VALUE ENGINEERING STUDY

**PI No. 621340-
SR 5 from SR 2 to Proposed McCaysville Bypass**

**PI No. 620490-
McCaysville Bypass from SR 5 to Tennessee State Line
Fannin County, Georgia**

Sept. 1, 2016

PROPOSAL NUMBER: B-4.0

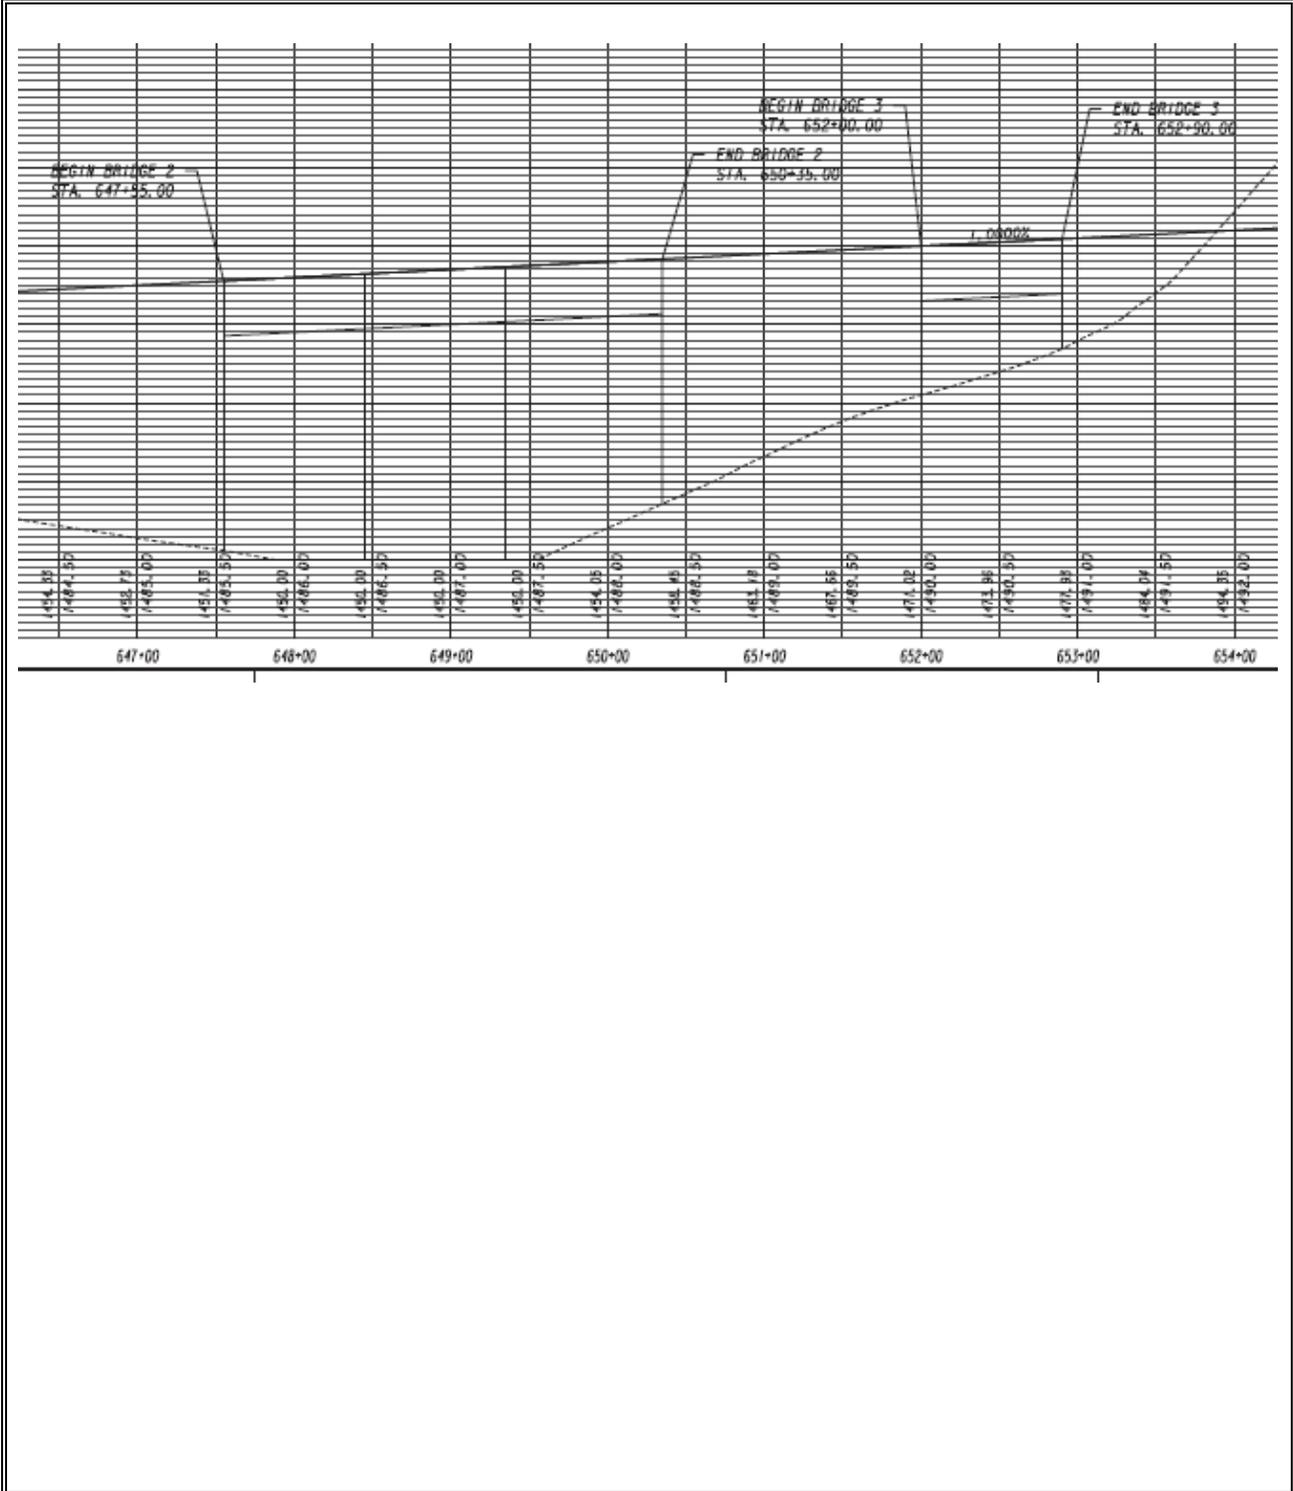
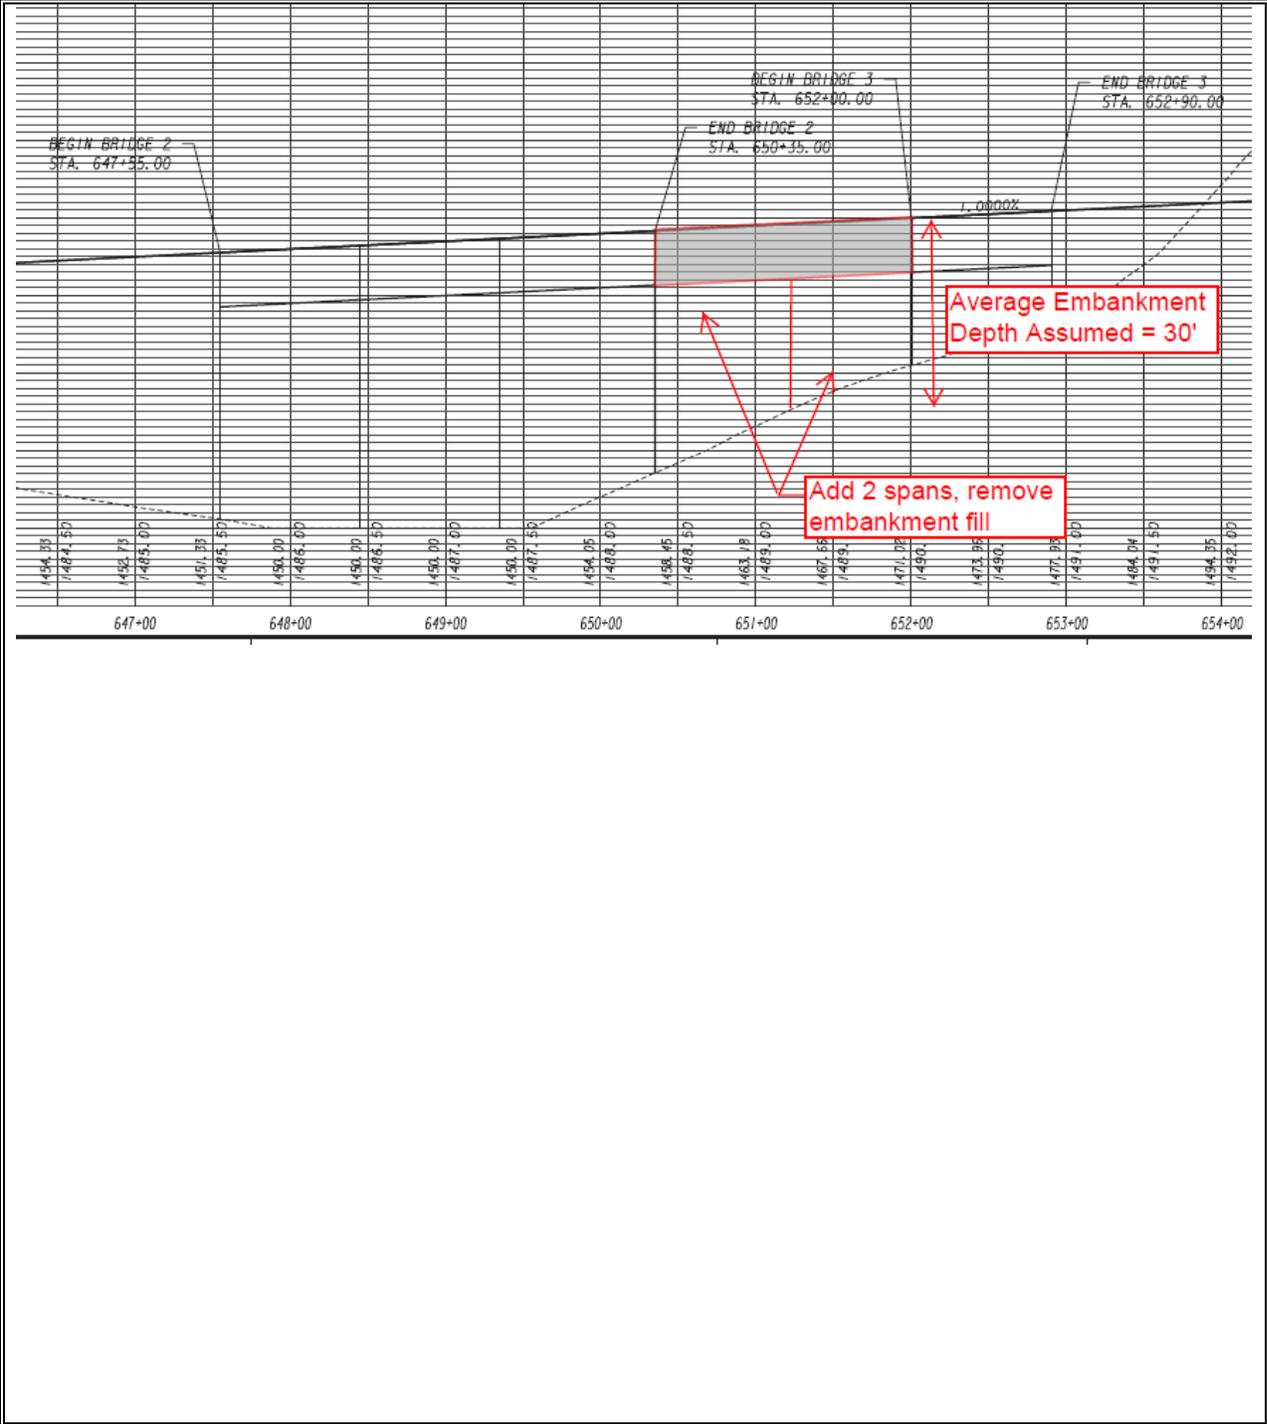
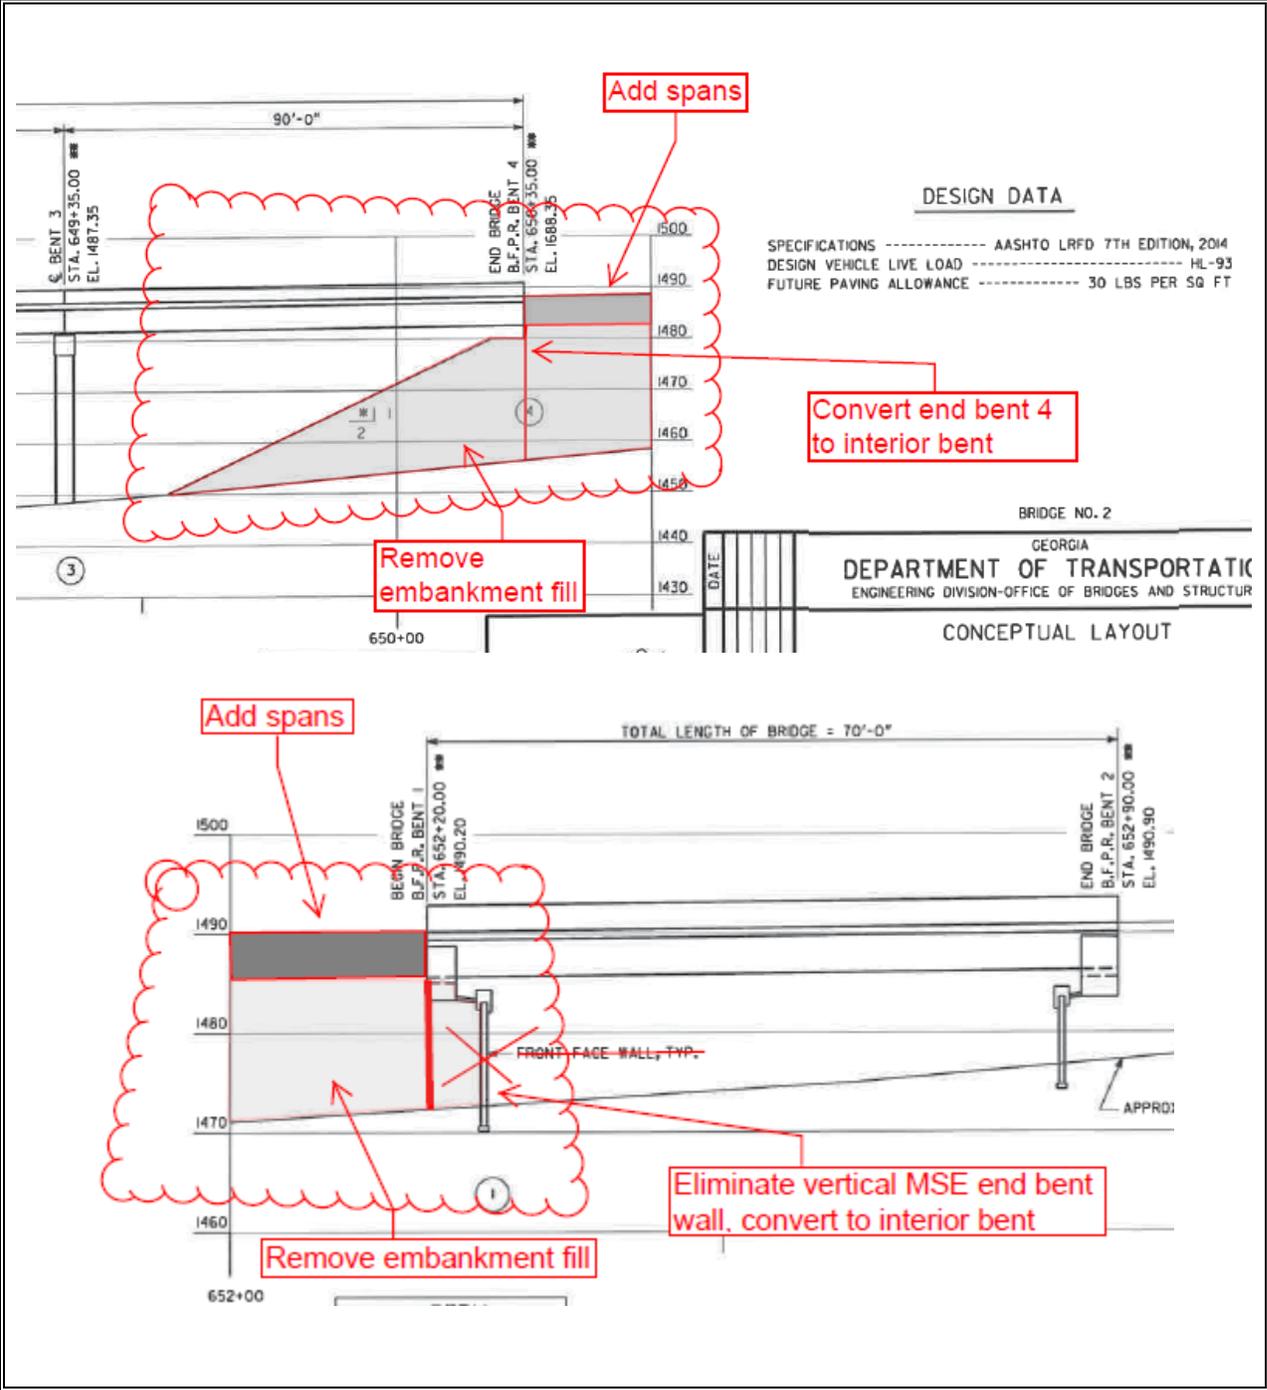
PROPOSED CHANGE: It is proposed to add 2 spans to bridge the 165-foot separation between bridges to form a single 505'-0" bridge and results in also eliminating the vertical MSE end bent wall at End Bent 1 of Bridge 3.

JUSTIFICATION: The proposed change improves constructibility by removing the difficulty of compaction between the bridges and possibility of future settlement and a "dip" between two rigid bridge structures. The proposed change results in no additional R/W impacts because the roadway is on structure.

PROPOSAL NUMBER: B-4.1

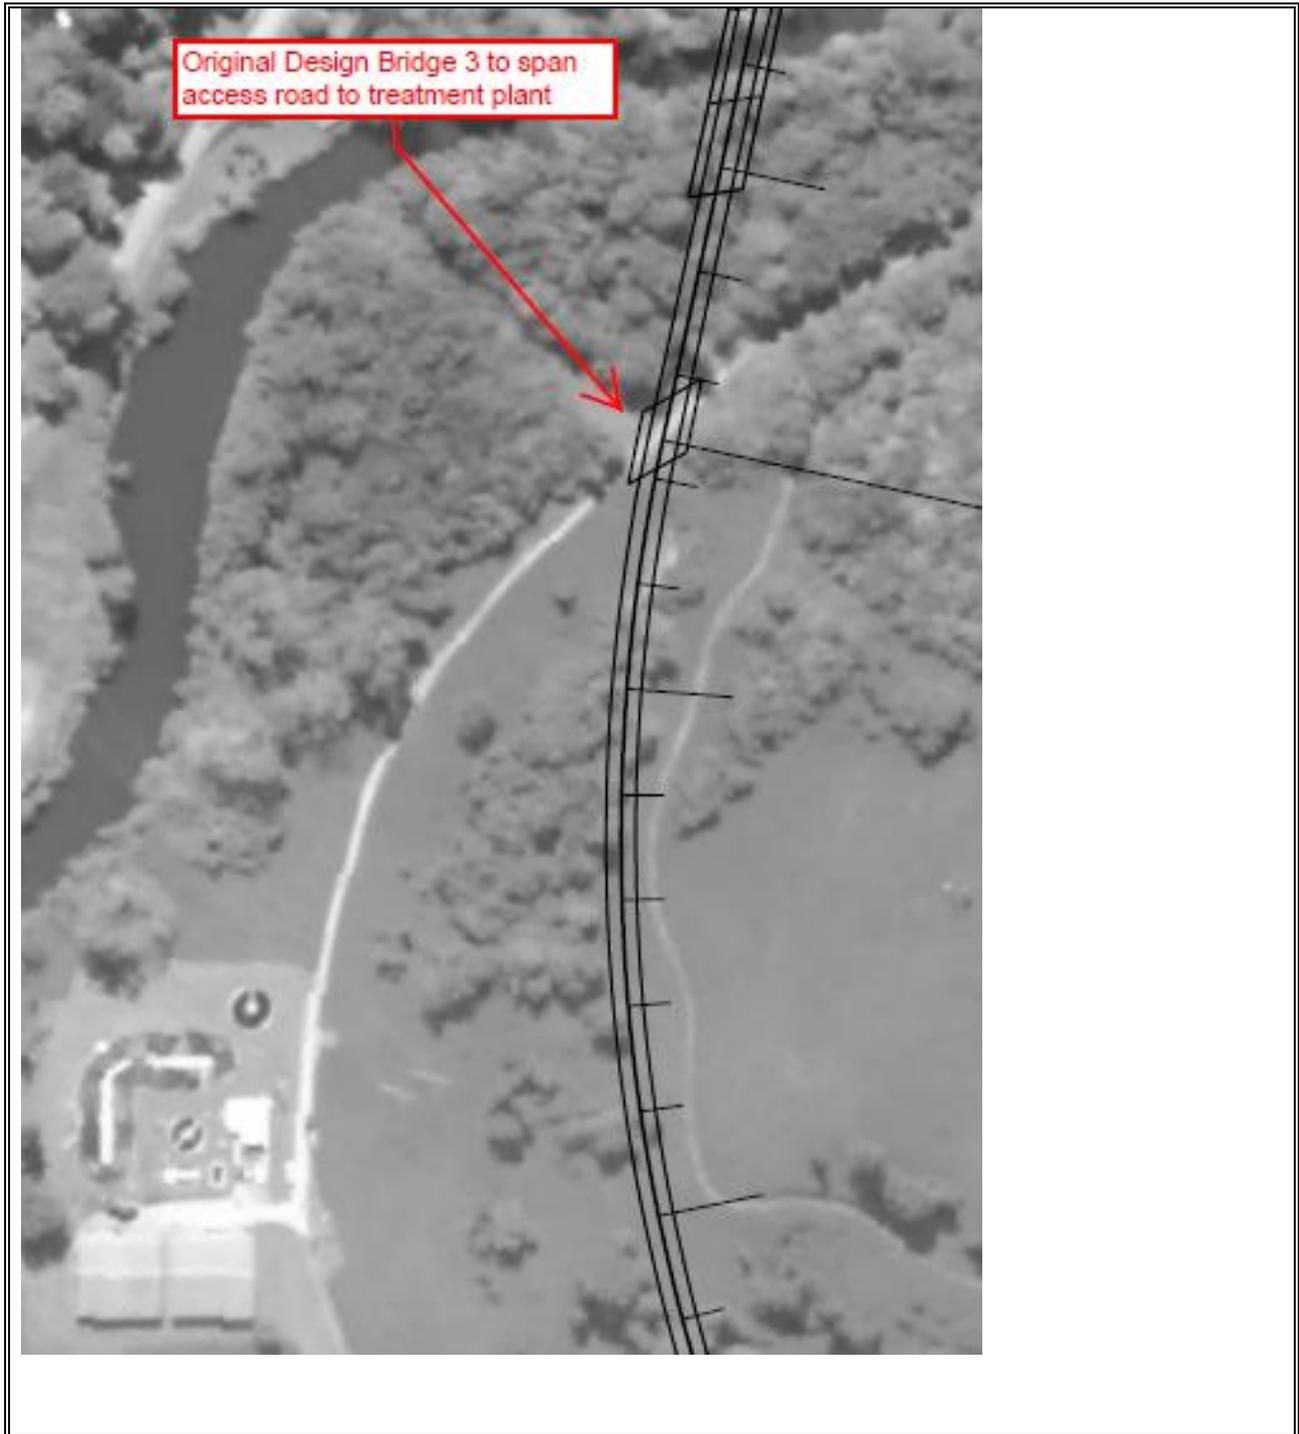
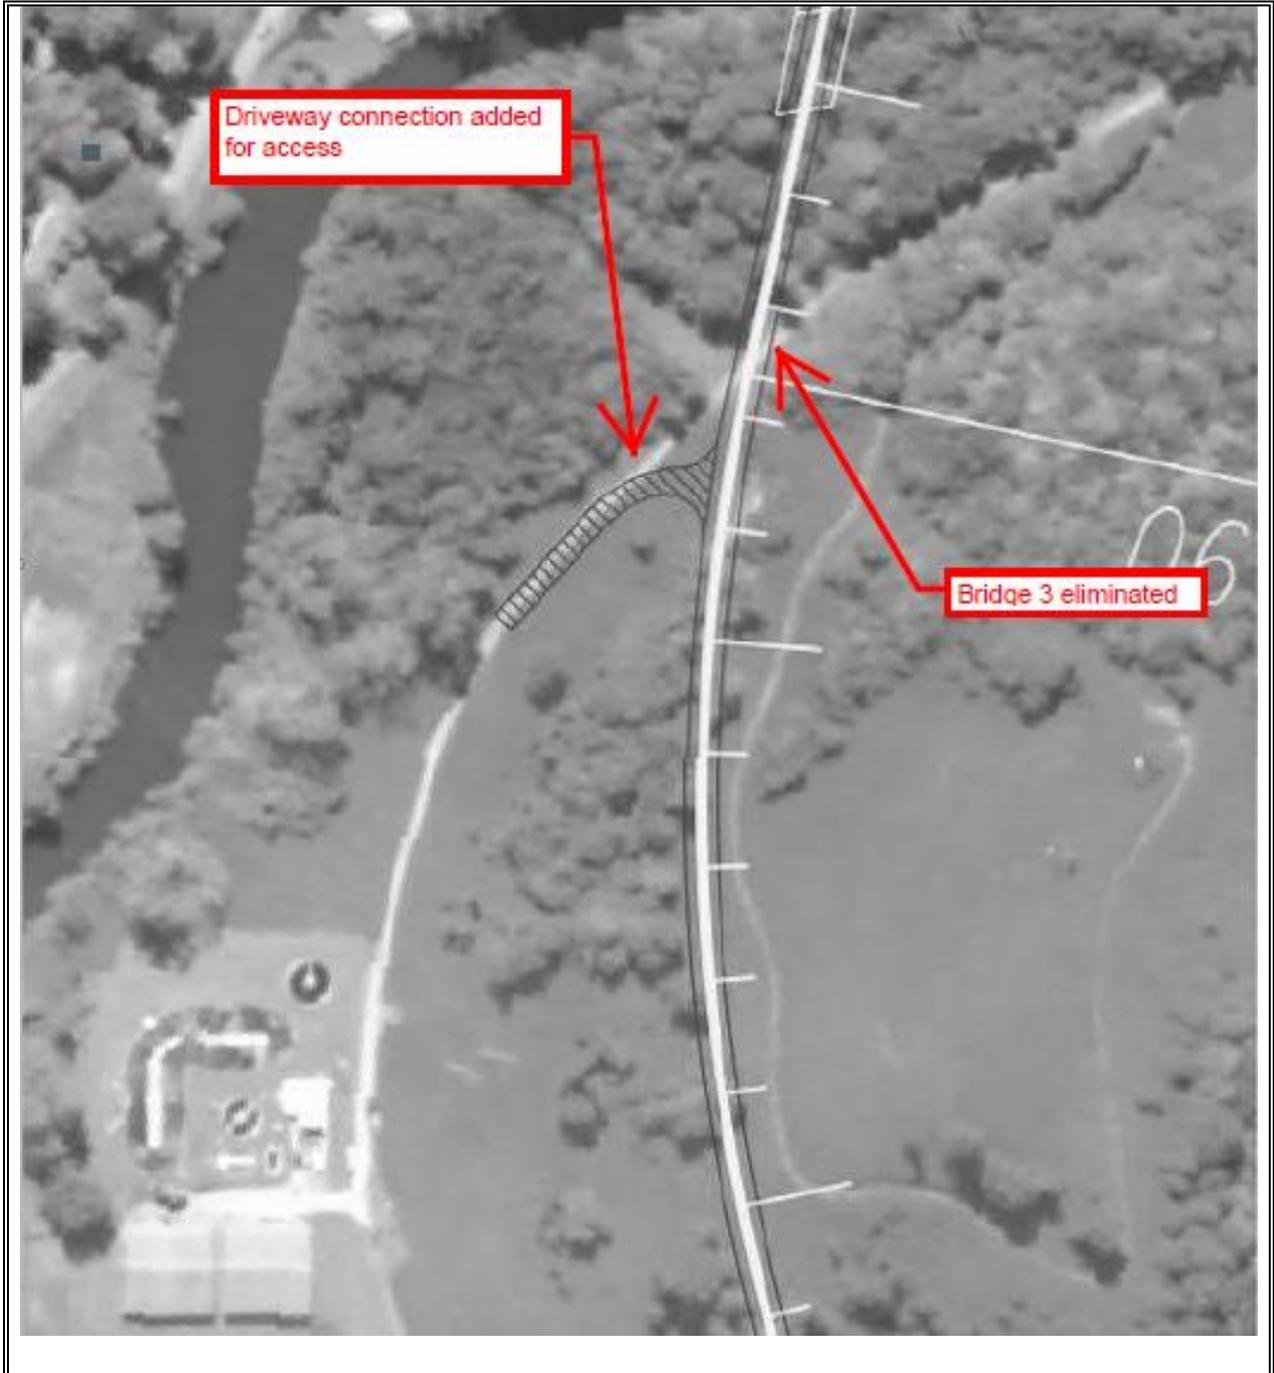
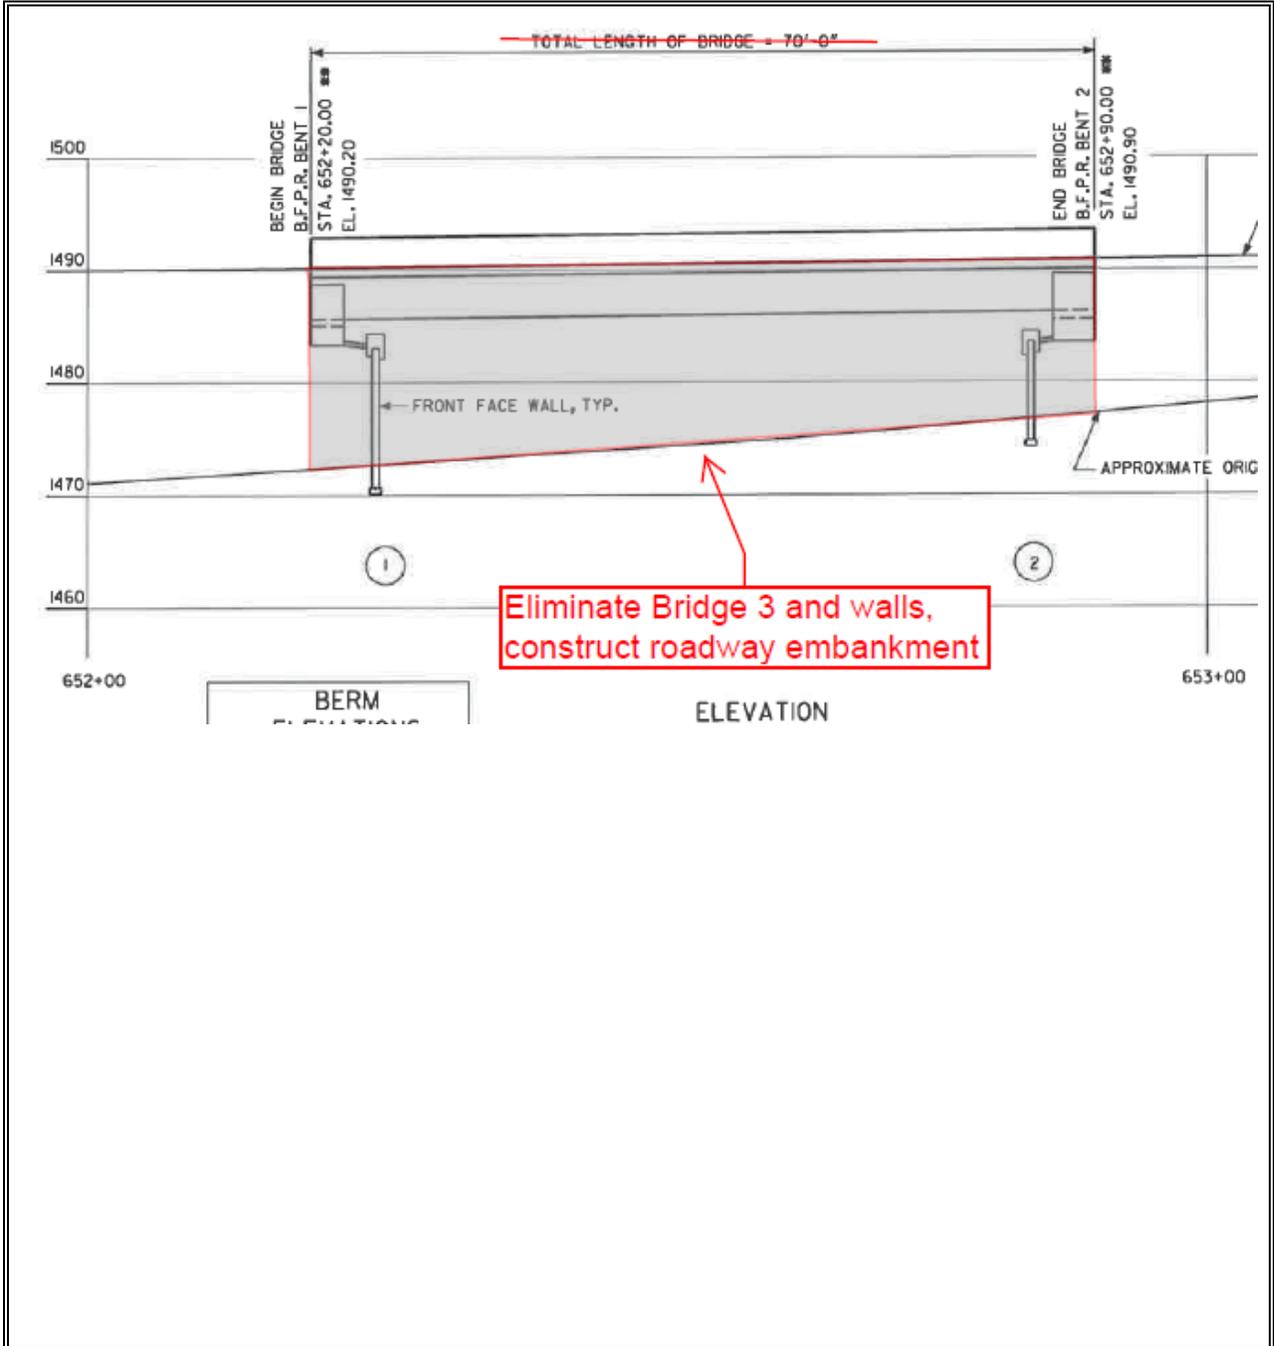
PROPOSAL DESCRIPTION: Eliminate Bridge 3 and Provide Driveway to East Side of Bypass

ORIGINAL DESIGN: The current design proposes Bridge 3 (70'-0") to span an existing access road to the Copper Hill Wastewater treatment plant.

PROPOSED CHANGE: It is proposed to eliminate Bridge 3 and provide access to the treatment plant through a driveway connection to the east side of the truck bypass at approx. Sta 654+00.

JUSTIFICATION: The proposed grade of the bypass (approx. 1,490) can tie to the existing grade of the treatment plant (approx. 1,465) via a driveway connection to the east side of the truck bypass. This connection will continue to serve the existing access pattern from W. Tennessee Ave. to the treatment plant, via the intersection of W. Tennessee Ave. and the proposed truck bypass segment. The proposed change is not anticipated to create a significant operational issue due to the anticipated low-volume of turns into the treatment plant on a daily basis. The proposed change results in only additional driveway easement for the connection.
